STATE OF NORTH CAROLINA
DEPARTMENT OF TRANSPORTATION

Subject: Permit Modification Request for **Nationwide Permit 23 and Tar-Pamlico Riparian Buffer Authorization Request** for the proposed replacement of Bridge Nos. 127 over the Tar River Overflow and 129 over the Tar River on SR 1565 in Pitt County. TIP No. B-3684; Federal Aid Project No. BRSTP-1565(4); State Project No. 8.2221101. Debit \$240 from WBS No. 33225.1.1

Pitt County
PROJECT: B-3684 (Bridge #129)

PROJECT REFERENCE NO. B-3684	SHEET NO. 4
ROADWAY DESIGN ENGINEER	
HYDRAULICS ENGINEER	
Buffer Drawing	
Sheet 6 of 9	
PRELIMINARY PLANS DO NOT USE FOR CONSTRUCTION	
INCOMPLETE PLANS DO NOT USE FOR ACQUISITION

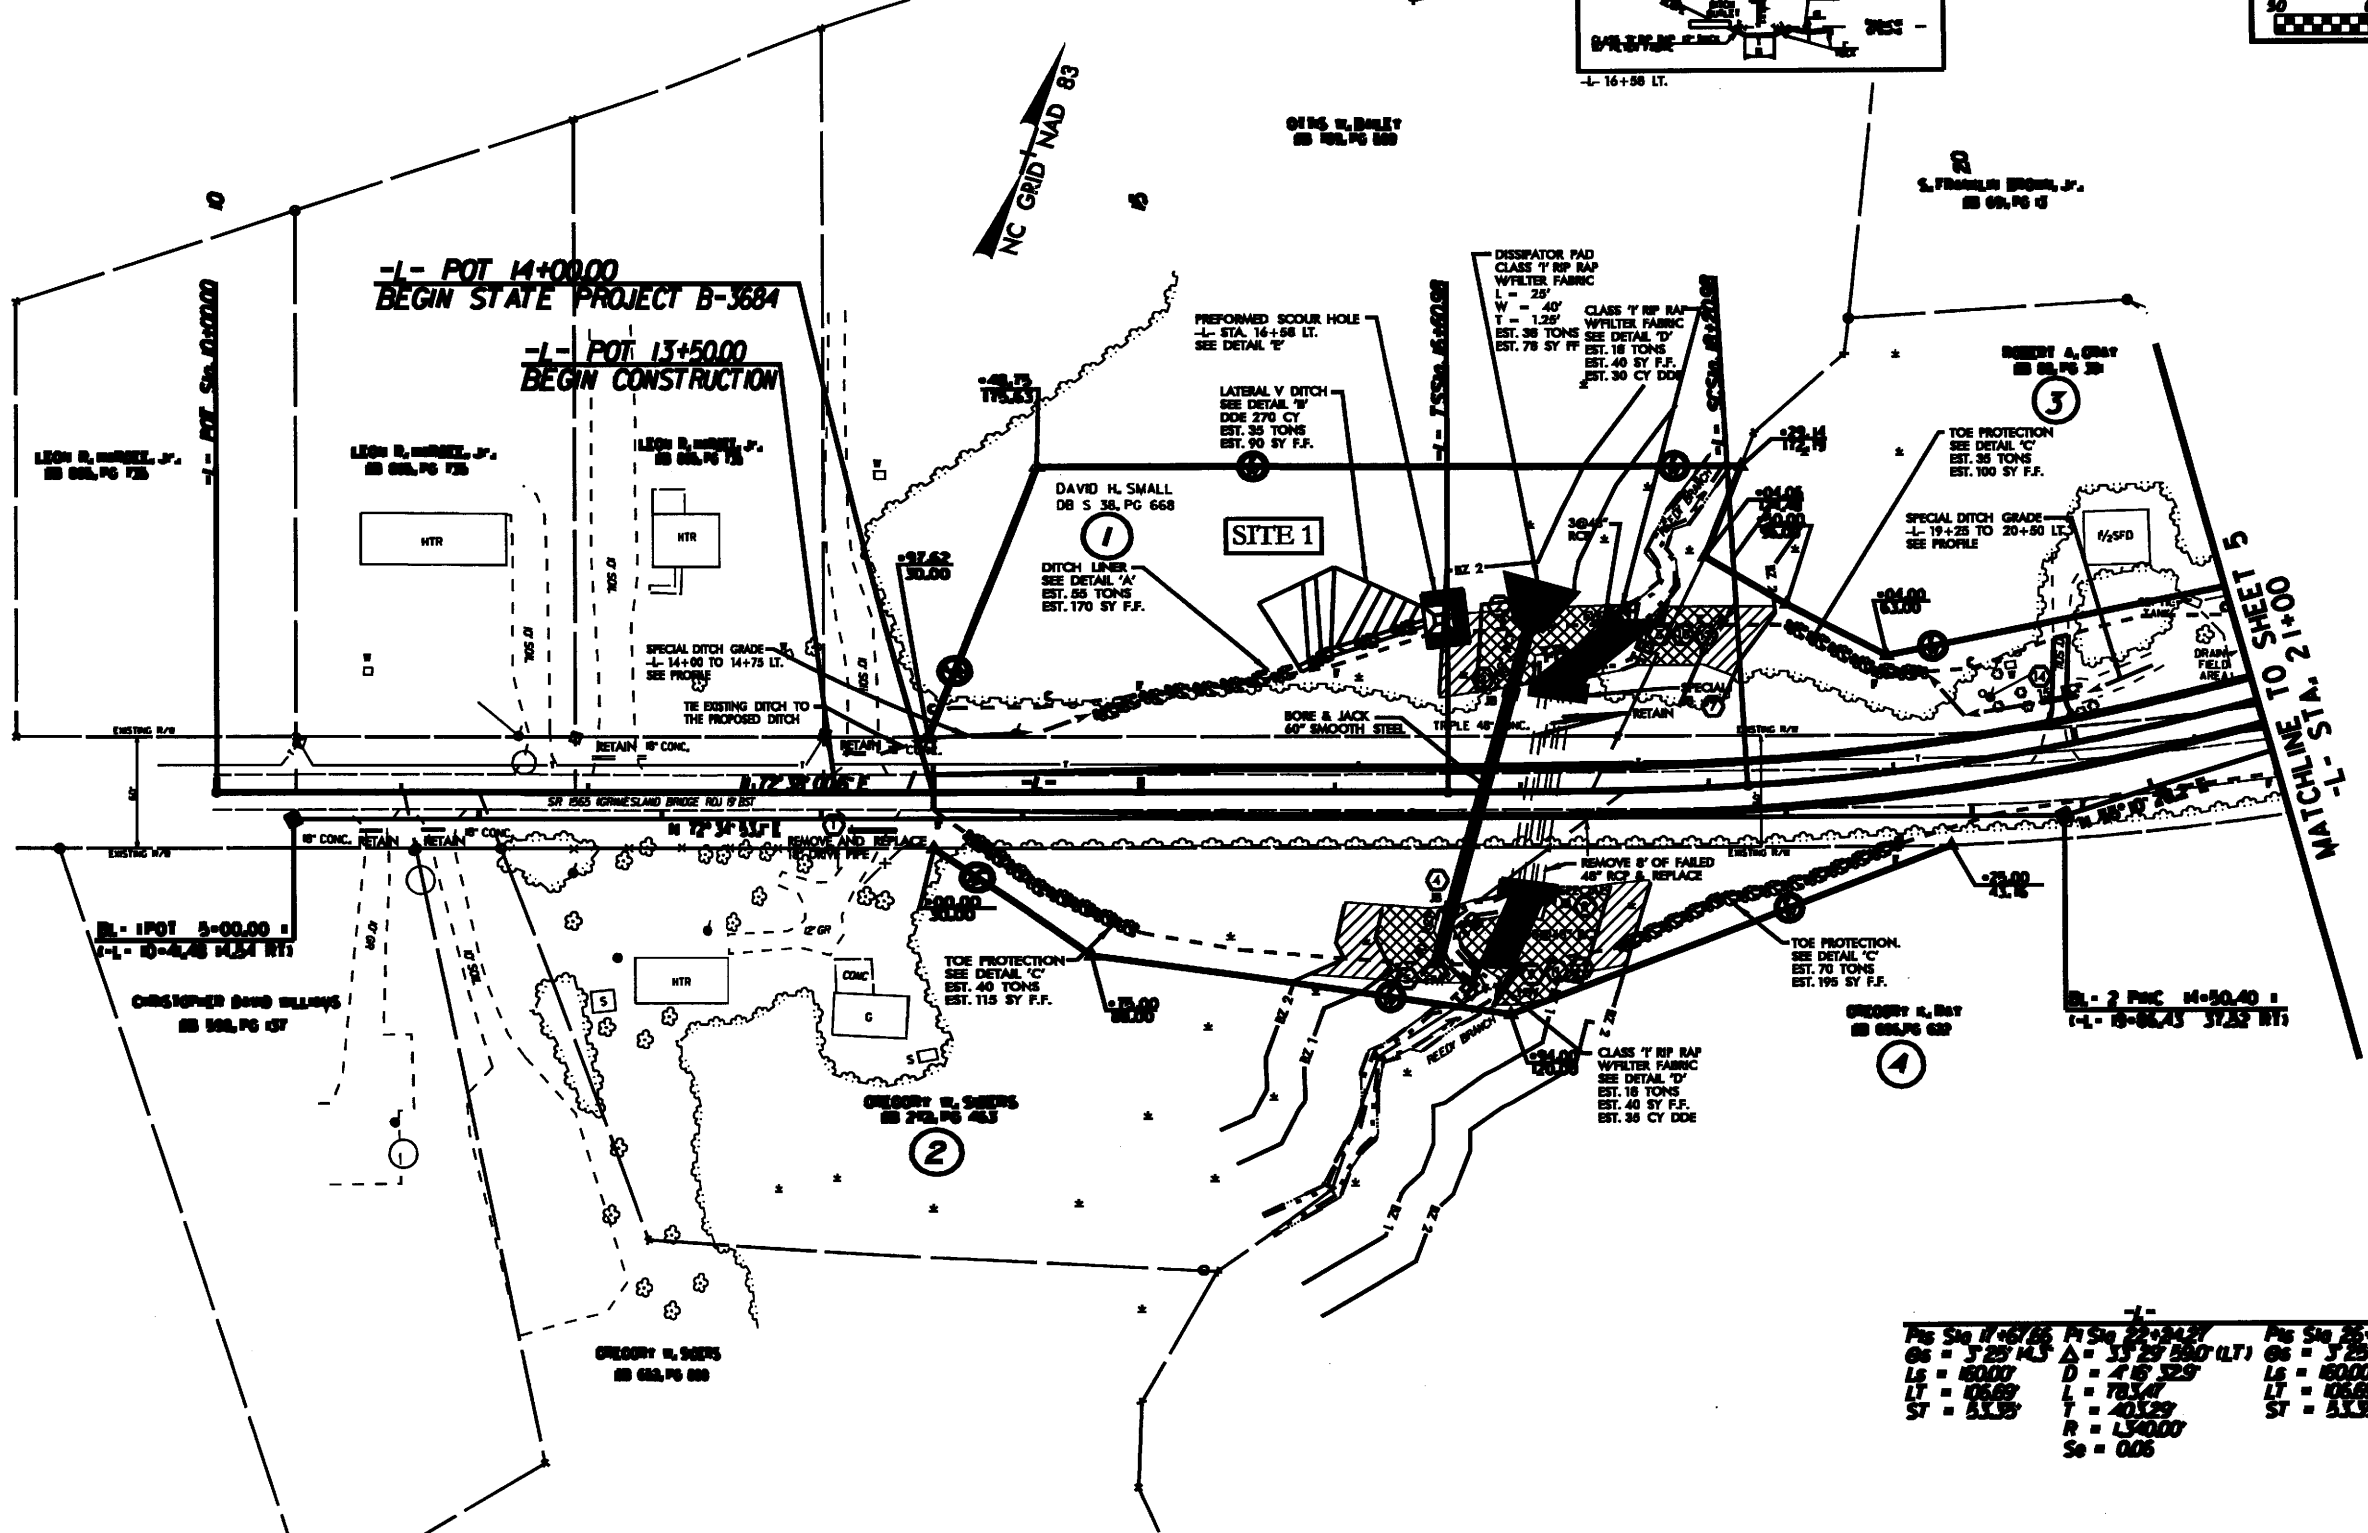
Please see the enclosed revised permit drawings, buffer drawings, and the revised debit ledger for the Grimesland Bridge Mitigation site for the above referenced project. Nationwide Permits 23, 33, and 12 were authorized by the USACE on March 20, 2008, General Water Quality Certification No. 3701 and a Tar-Pamlico River Buffer Authorization was authorized by DWQ on April 25, 2008 for 1.29 acres of permanent wetland impacts and 181 linear feet (0.04 acre) of permanent surface water impacts; and a total of 12,717 ft² of impacts to riparian buffers. During the preconstruction meeting held on April 7, 2009, it was noted additional riparian wetland impacts and surface water impacts (0.07 acre permanent riparian wetland impacts, 0.01 acre of temporary riparian wetland impacts, and 0.03 acre of surface water impacts) in the form of fill and mechanized clearing will be required around bents for the new bridge. In addition, 4,988 ft² of allowable impacts to riparian buffers were omitted from buffer sites 1 and 2 of the original permit application.

Site	Station	WETLANDS IN BUFFER	
		ZONE 1 (ft ²)	ZONE 2 (ft ²)
1	15+80 TO 18+50	8079	3830
2	29+40 TO 33+80	2726	1830
Total		10805.0	5660.0

Permit Drawing
Sheet 8 of 35

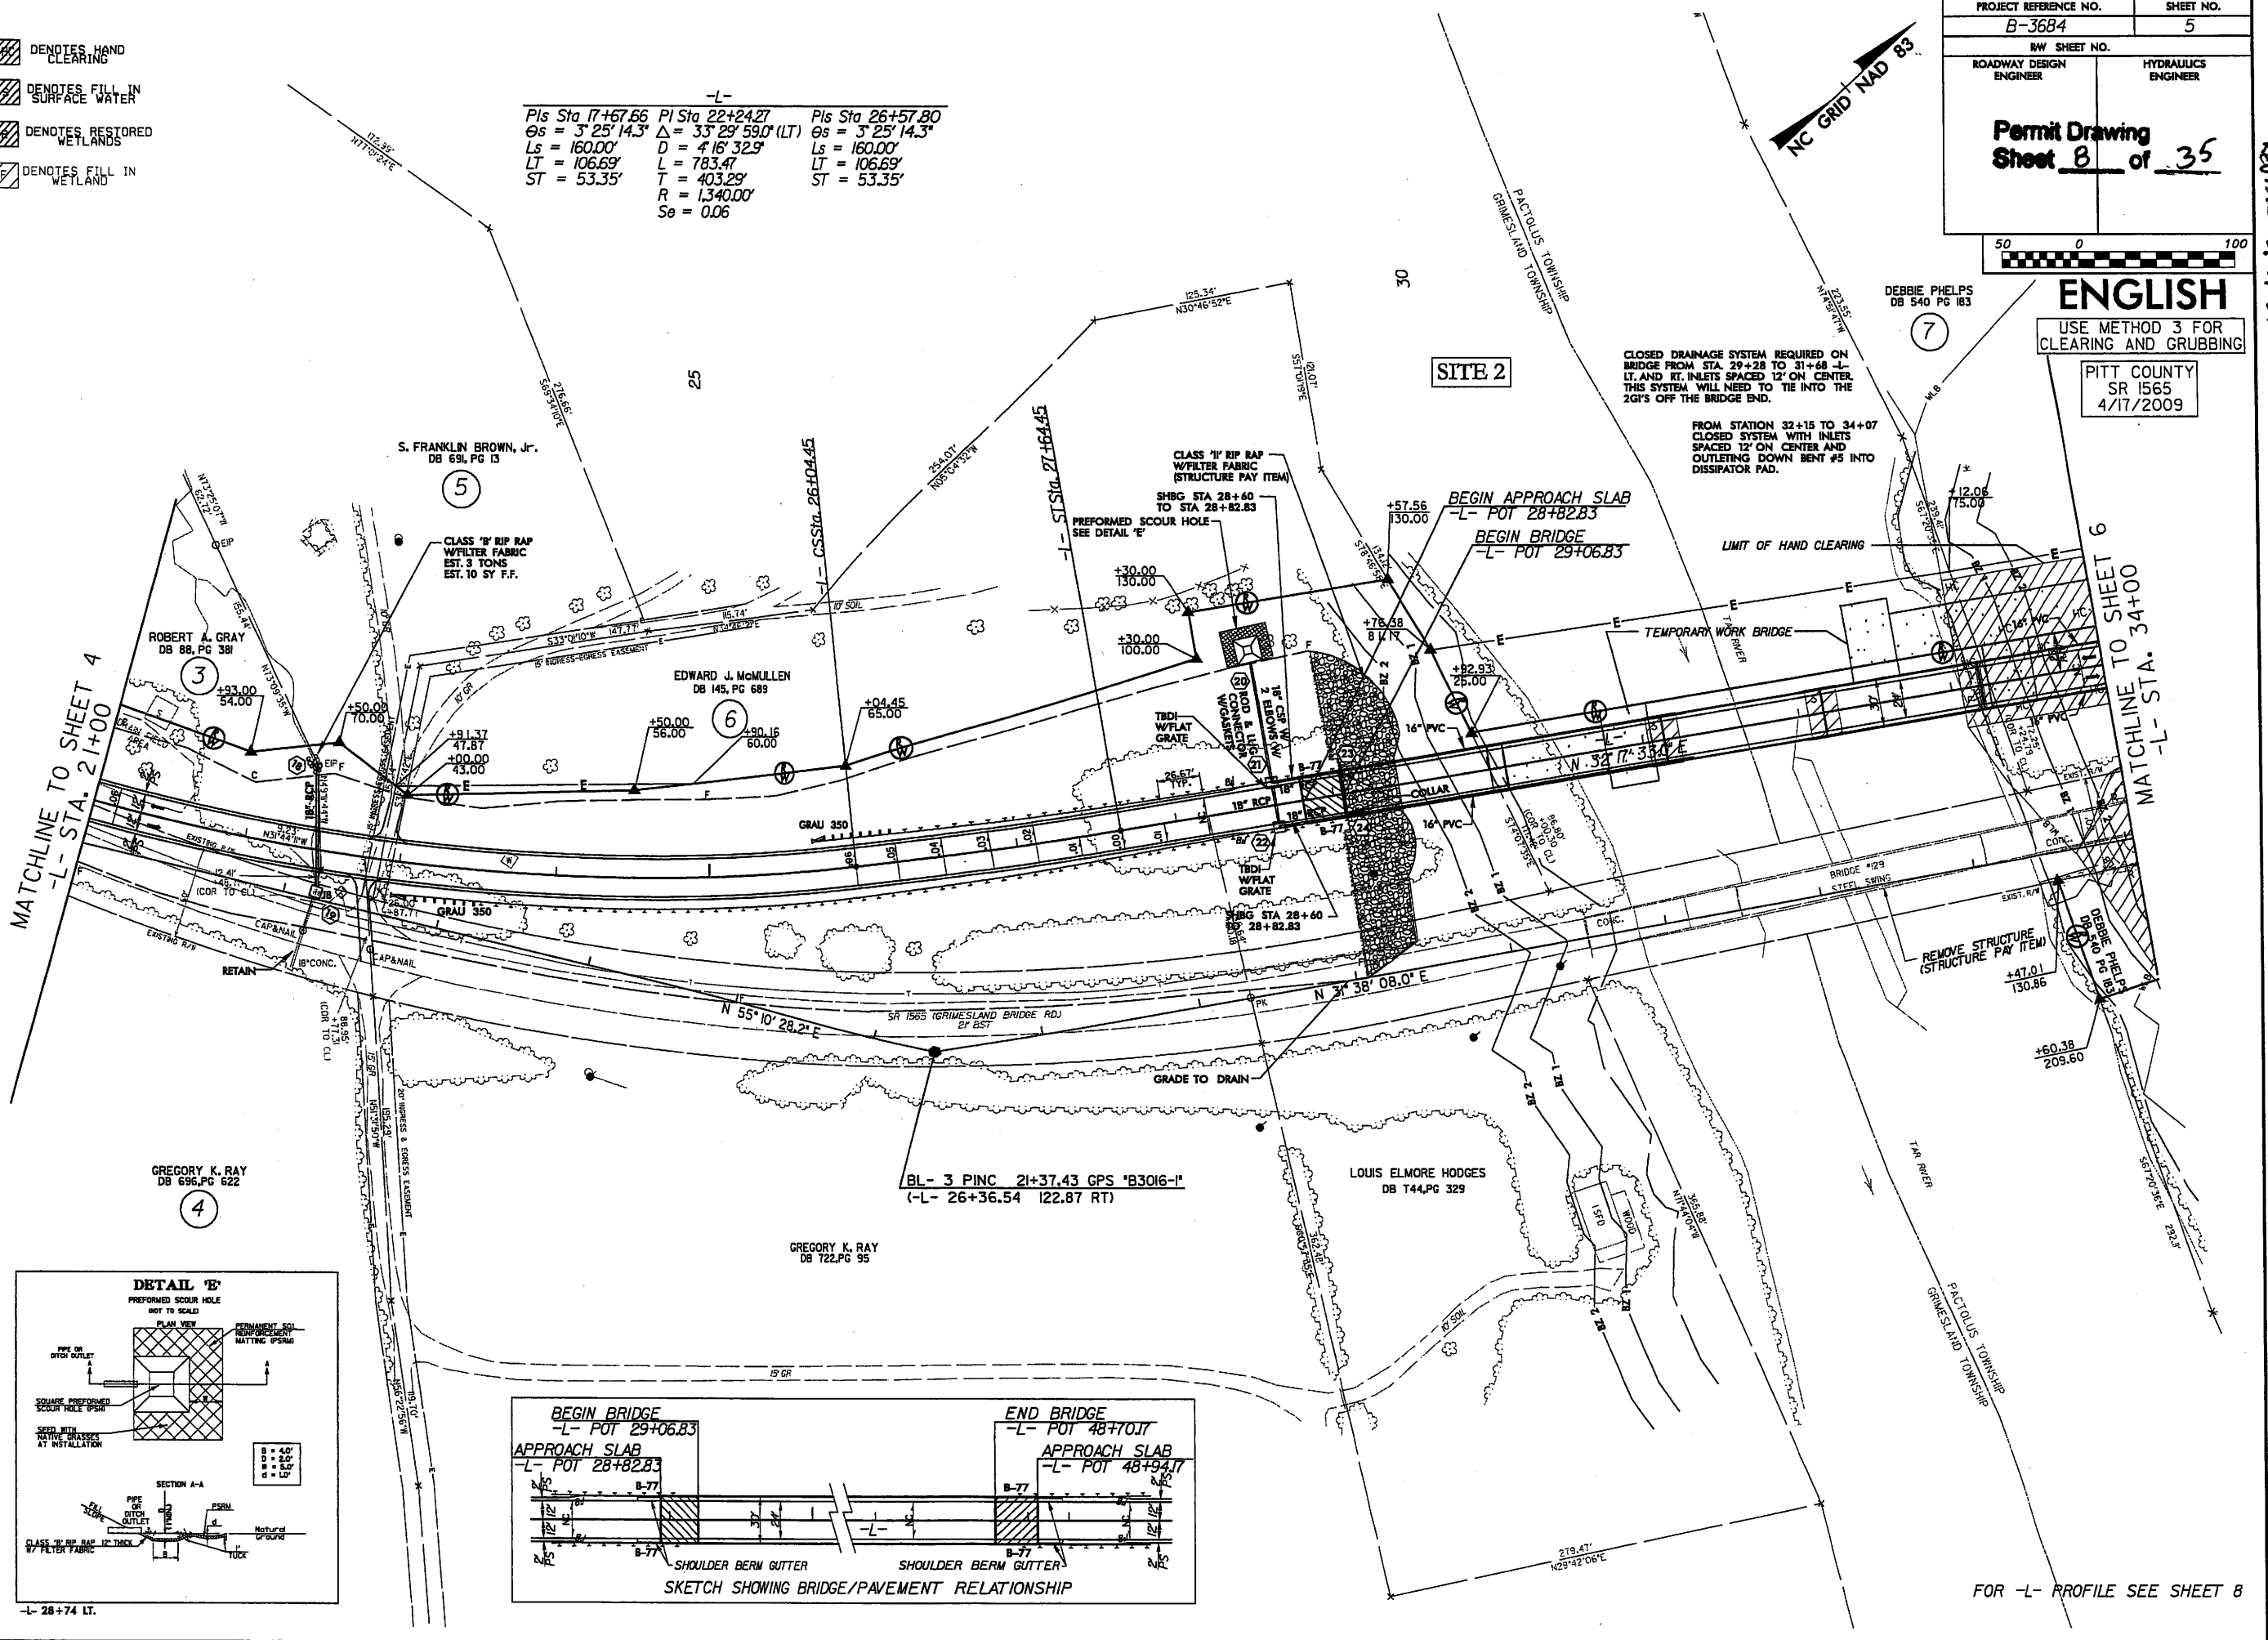
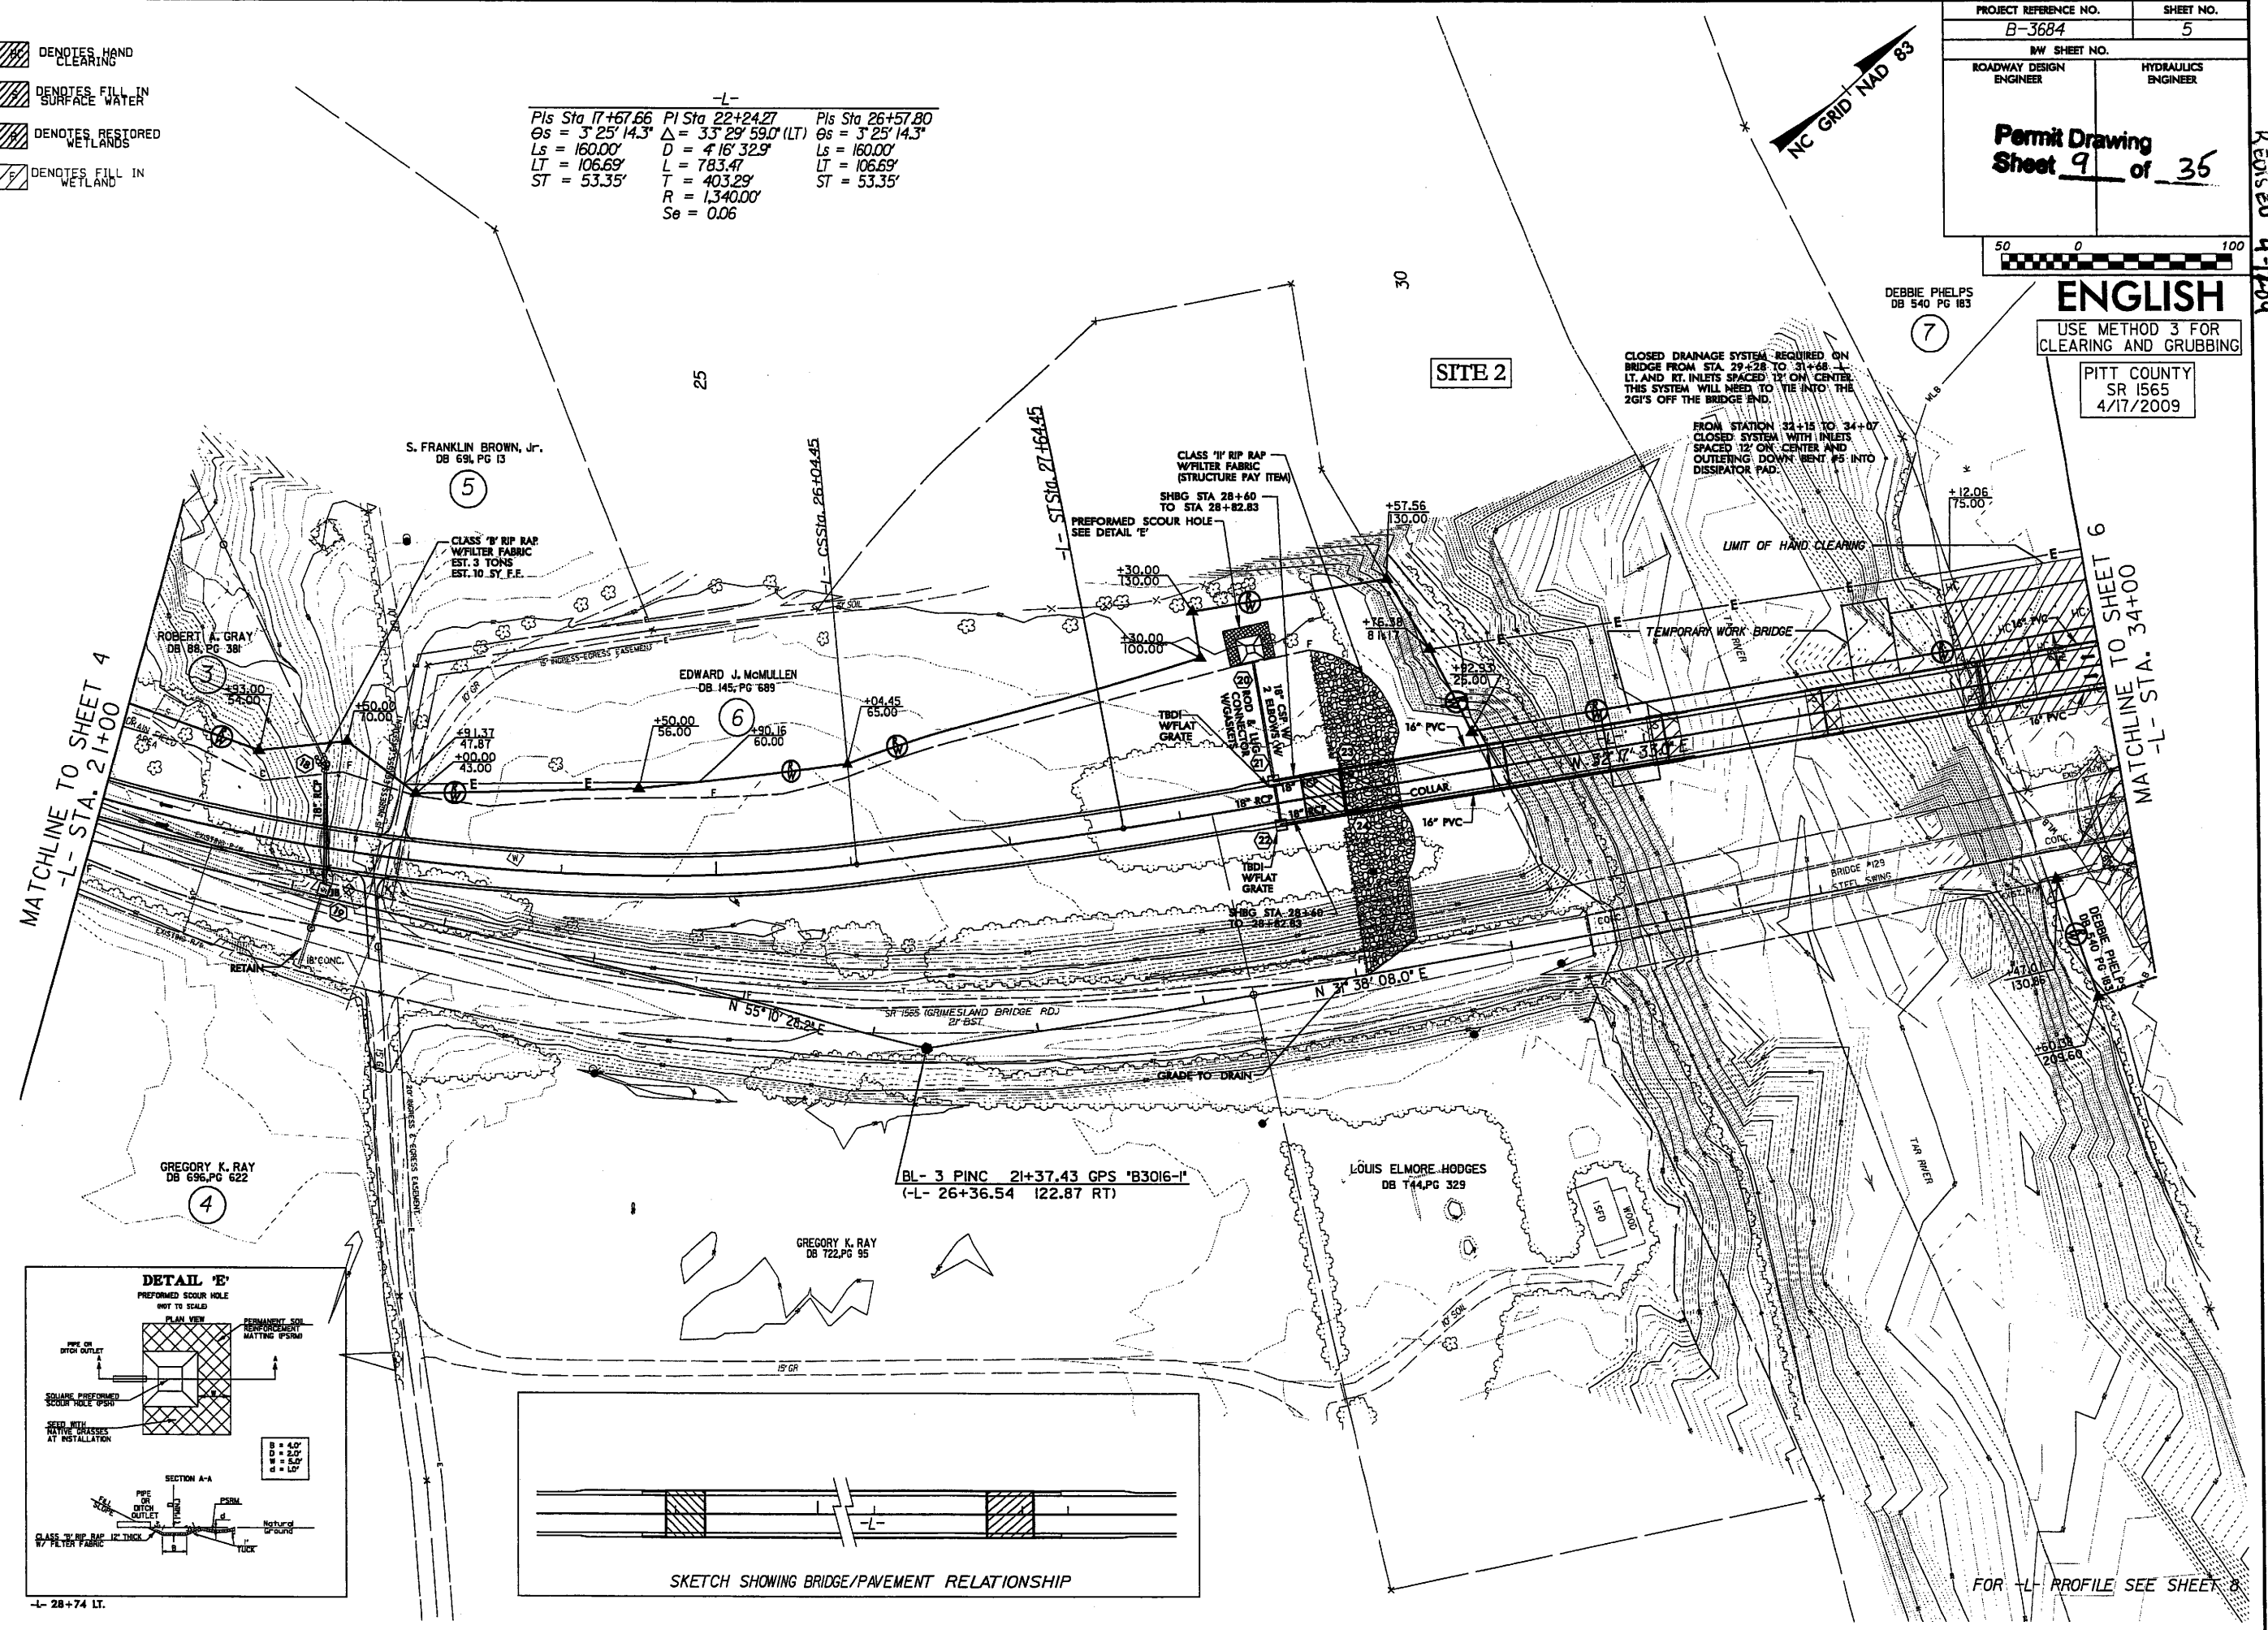
12-07-07 R/W REVISION ADJUSTED EASEMENT TO PARCEL NO.7 DUE TO PERMIT DRAWING IN THE GRIMESLAND MITIGATION SITE.

REVISIONS
12-07-07 R/W REVISION ADJUSTED EASEMENT TO PARCEL NO.7 DUE TO PERMIT DRAWING IN THE GRIMESLAND MITIGATION SITE.
